Rev. Date: 2-18-46

SUBJECT: Reinforcement of Stabilizer Yokes

MODELS AFFECTED: E2 and F2 Cubs

SERVICE BULLETIN NO. 8

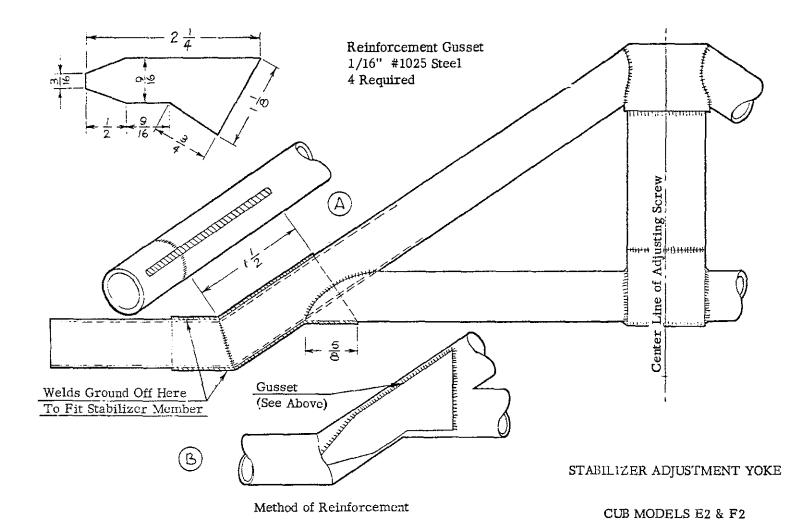
Due to the ever-present possibility of fatigue cracks occuring in the vicinity of a welded joint, it is in the interest of safety that the reinforcement in question should be adequate. It is therefore necessary, in the case of every E2 or F2 "Cub" now in service, that the stabilizer adjustment yoke be inspected for conformity with the approved drawing, and have additional reinforcement added if the present one is unsatisfactory.

It will be seen, upon examination of the yoke at the joint located just outside the fuselage, that there is a welded seam lengthwise of the tubing on both top and bottom. These seams indicate where an internal gusset, as shown at "A" in the sketch, has been inserted in slots in the tubing and welded in place at these slots.

The dimensions of 1-1/2'' on top and 5/8'' on the bottom, as shown in the sketch, indicate the correct distance which the gusset should extend inward. If, when measured in the exact manner as indicated, these seams are found to be shorter than the dimensions given, it will be necessary to add an external reinforcement.

The method of reinforcement as shown at "B" on the drawing will be satisfactory. Four gussets of the form indicated should be made and welded in place, one on the front and one on the back of each joint.
